**ADDENDUM NUMBER ONE TO PLANS AND SPECIFICATIONS FOR  
2022 HVAC RENOVATION FOR  
RAINS JUNIOR HIGH SCHOOL  
RAINS INDEPENDENT SCHOOL DISTRICT**

**ENGINEER: EMA ENGINEERING & CONSULTING  
328 South Broadway  
Tyler, Texas 75702**

02/08/2022

MEP1.7

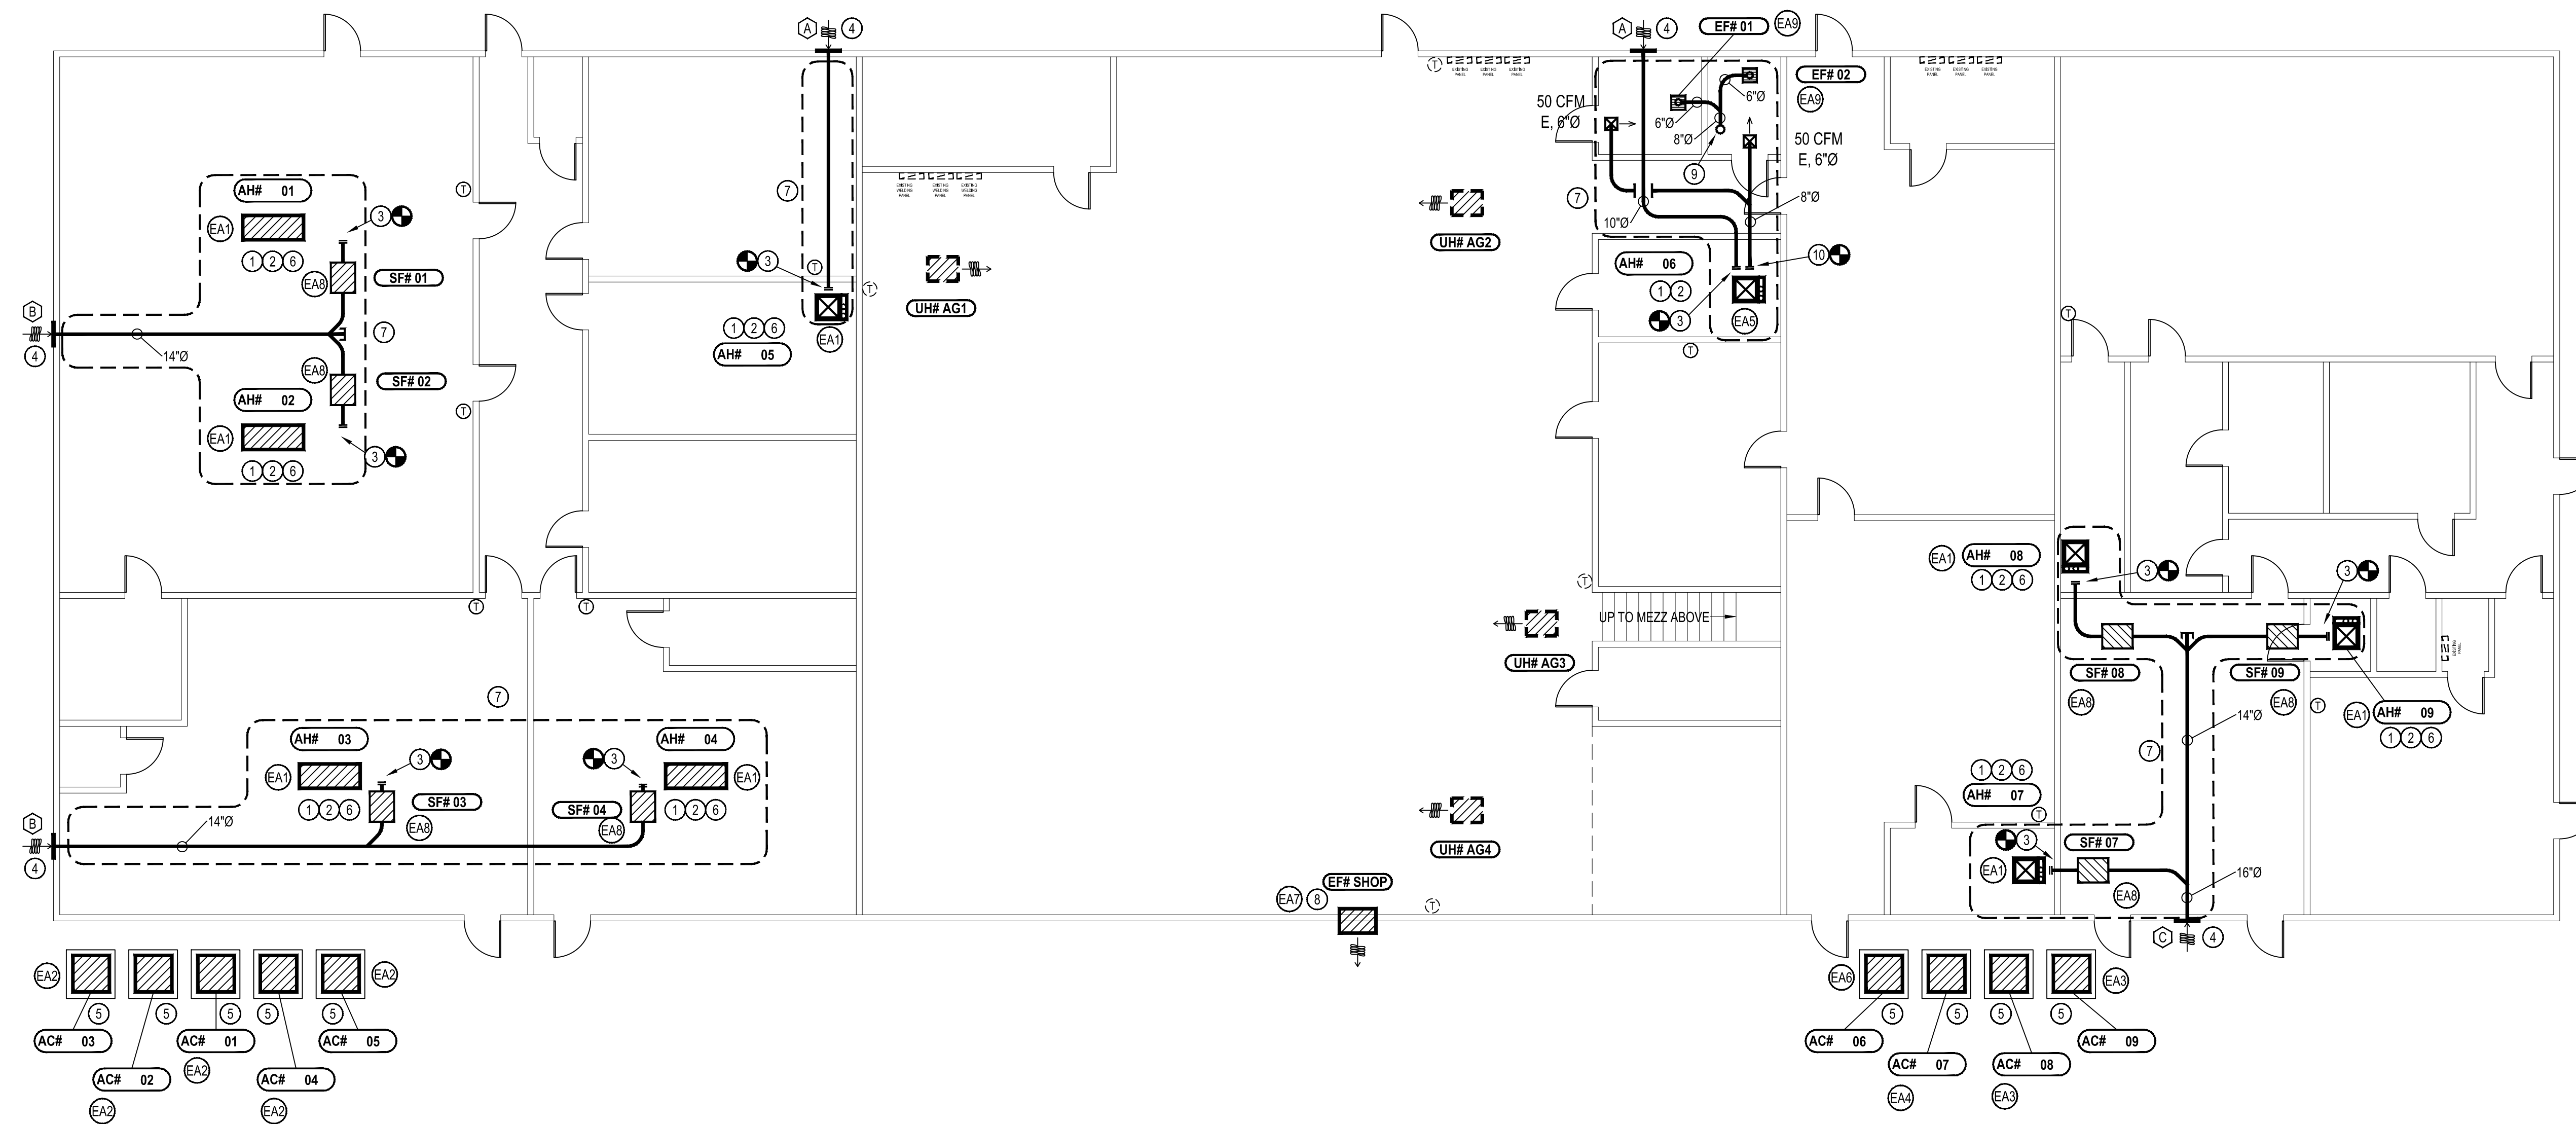
**SHEET MEP1.7**

- A. Refer to the attached sheet for the Vocational Ag MEP floor plan.

1 DUCT TAKEOFF  
N.T.S.

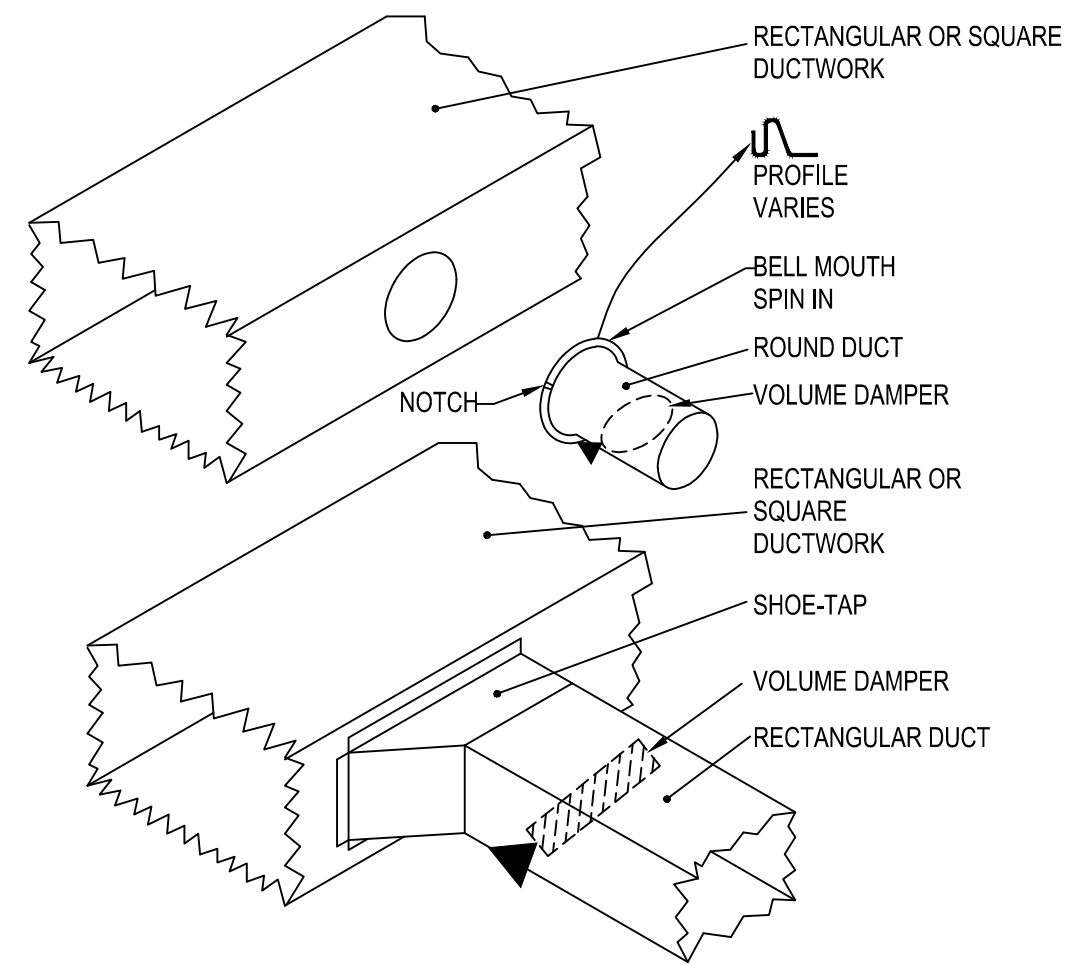
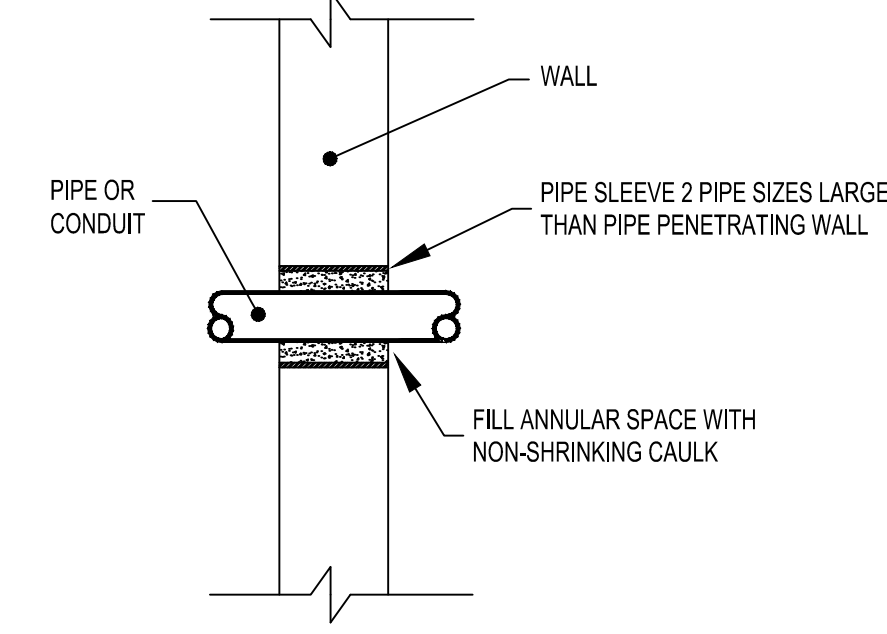
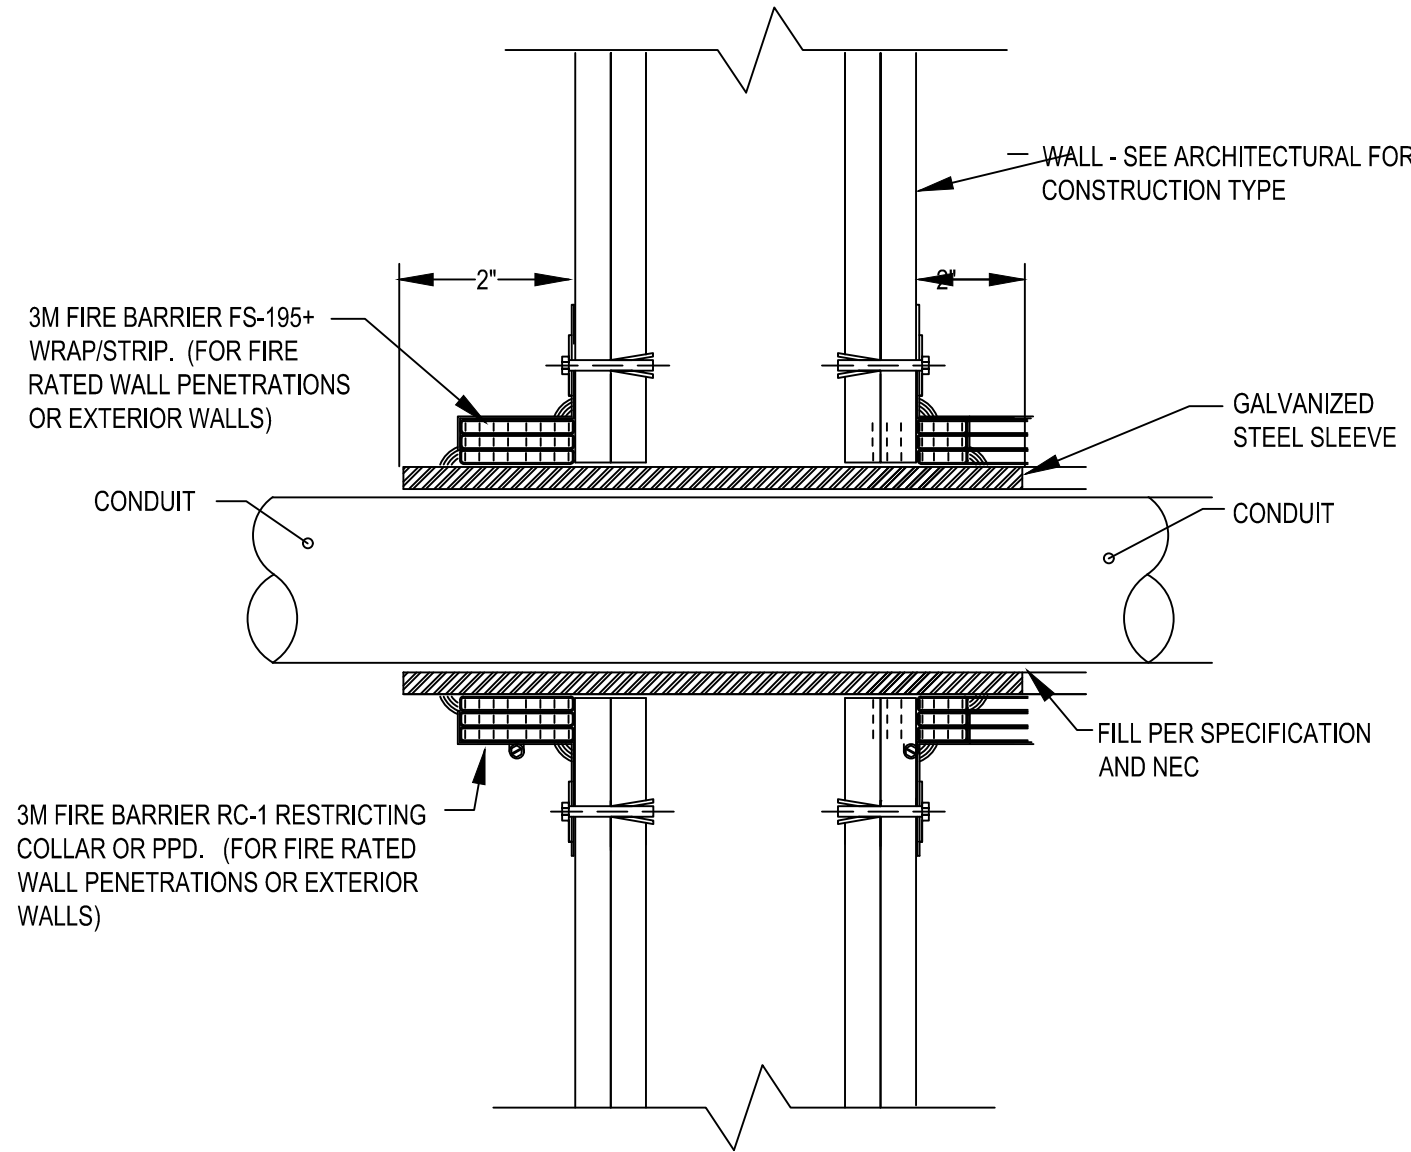
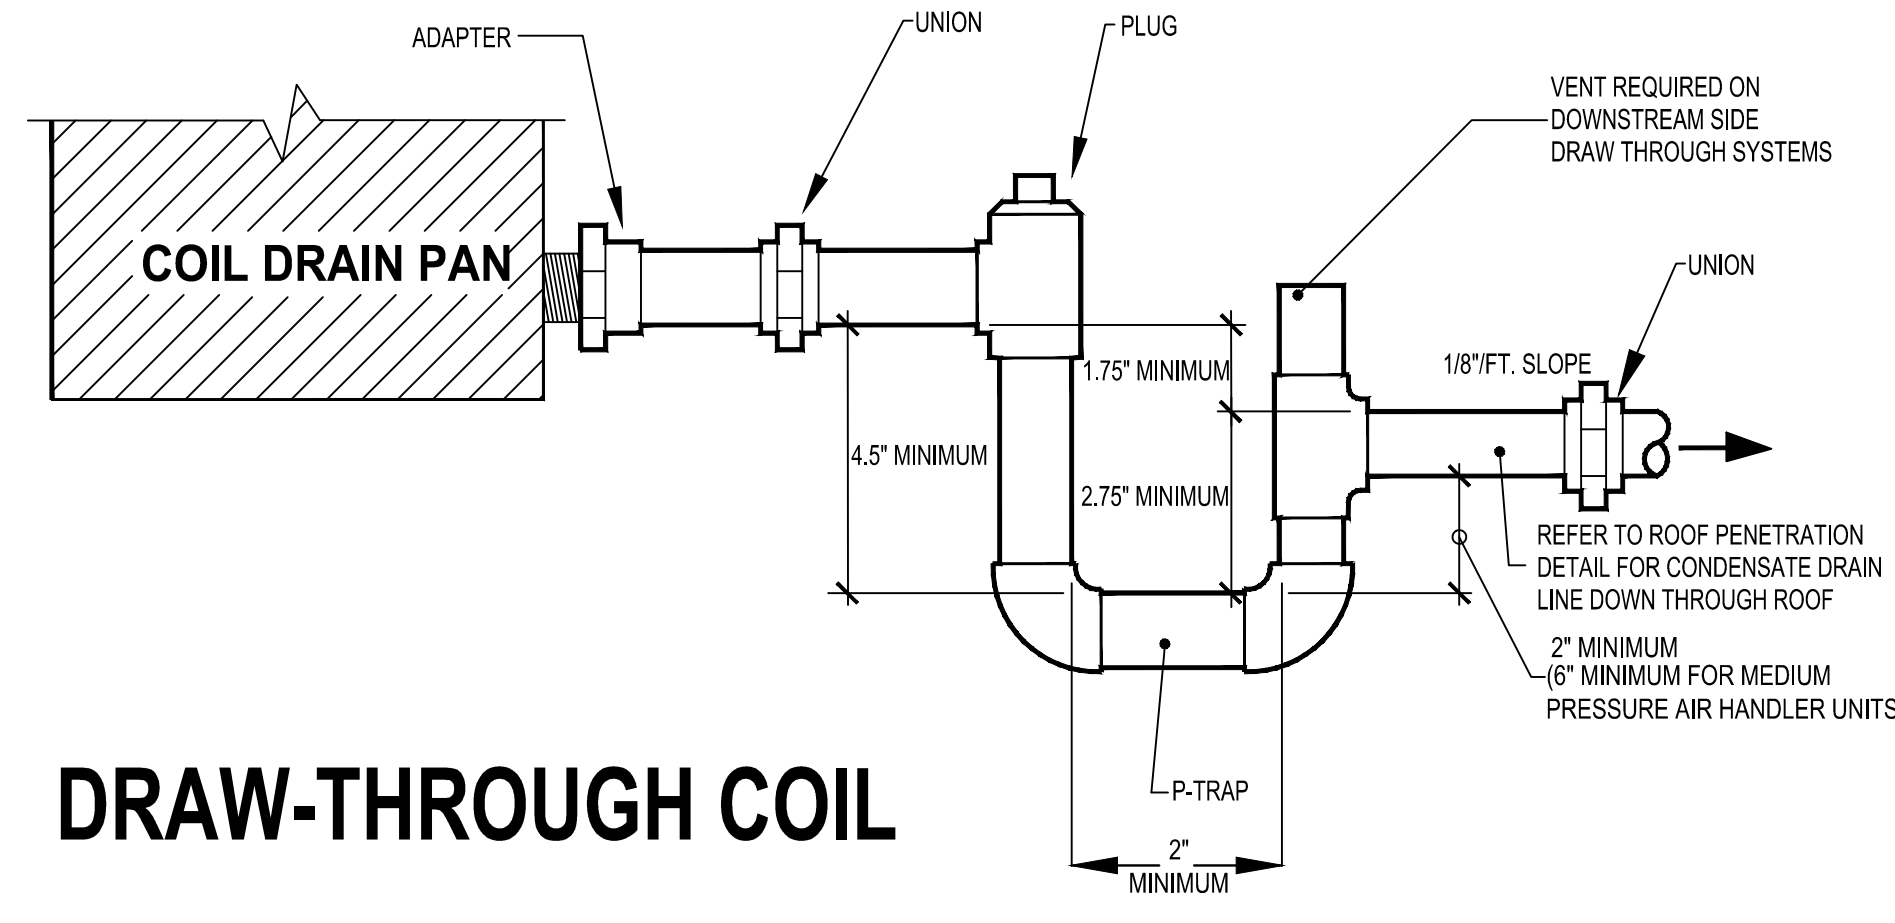
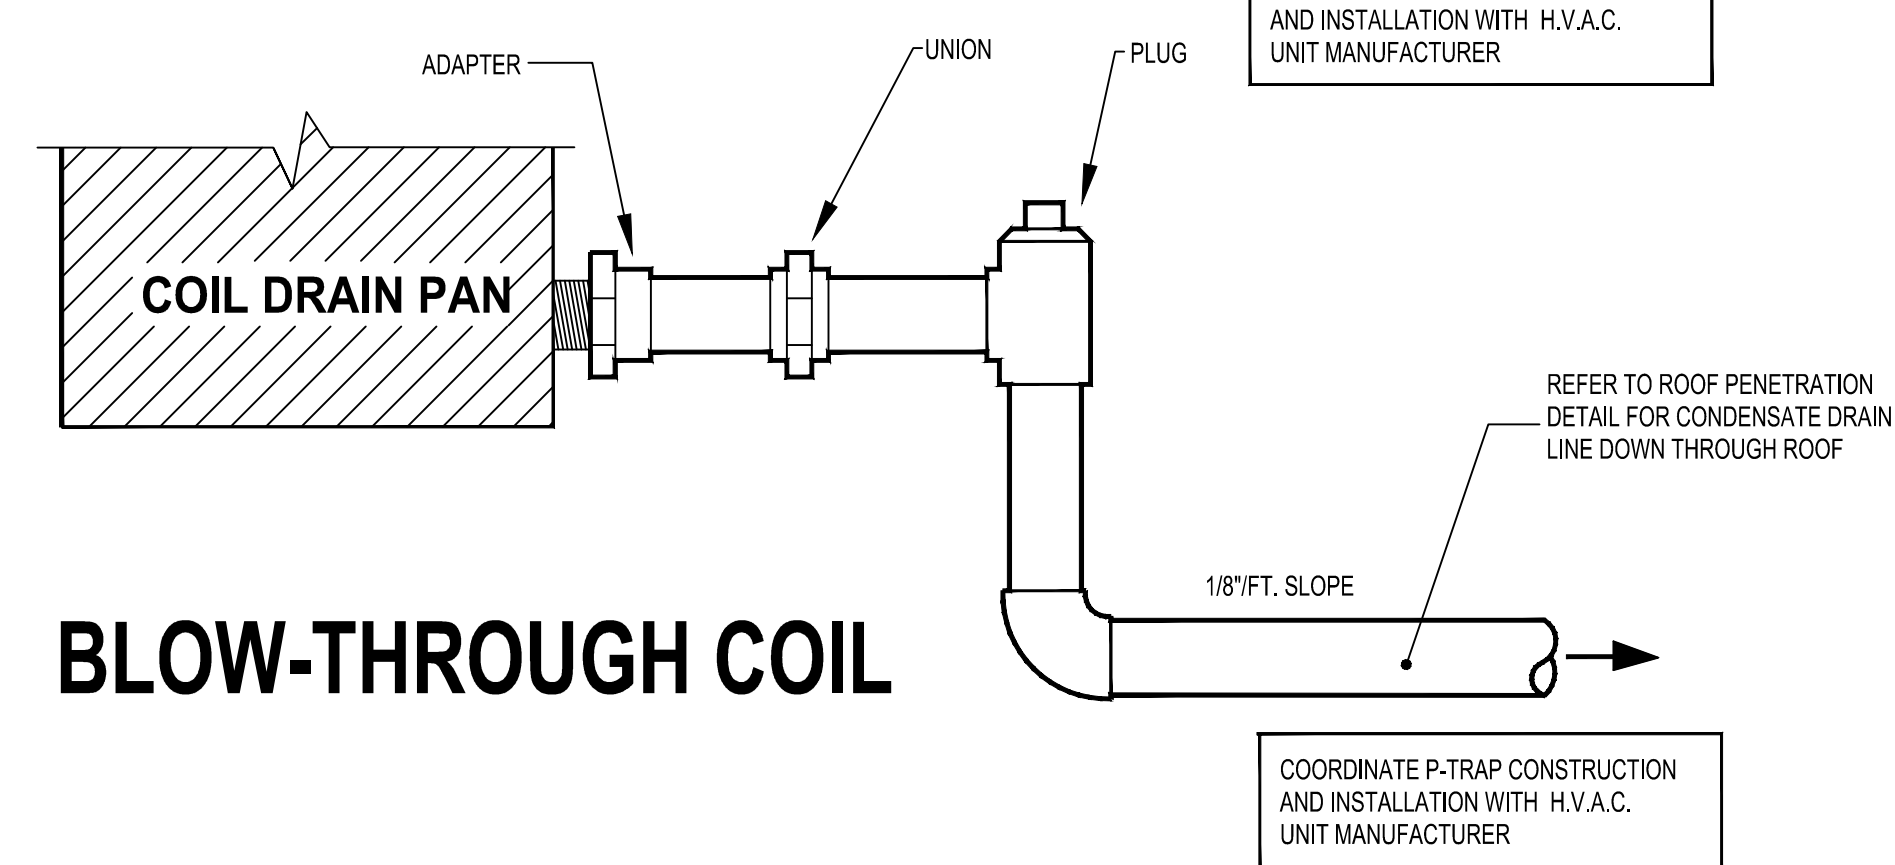
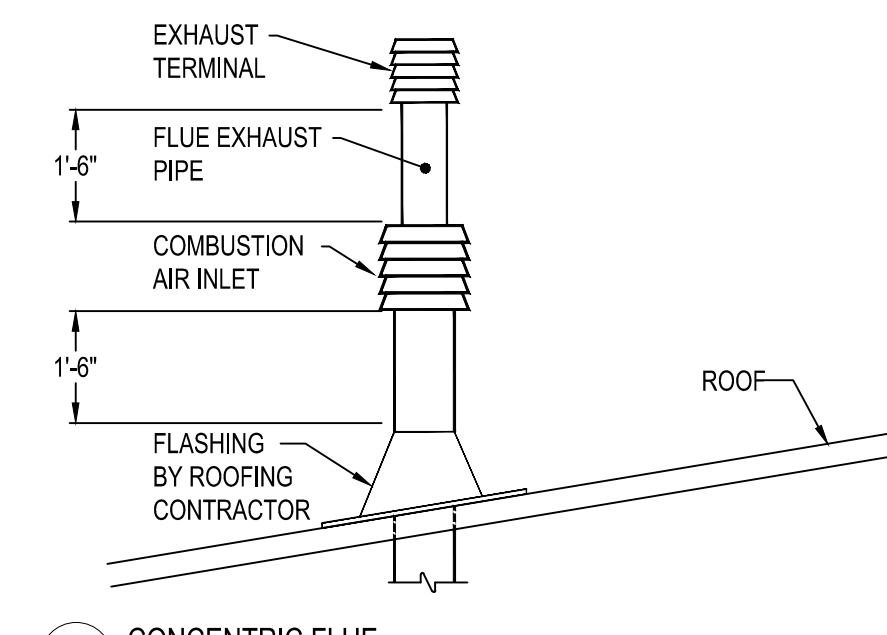
**SHEET MEP7.2**

- A. Refer to the attached sheet for detail corrections.
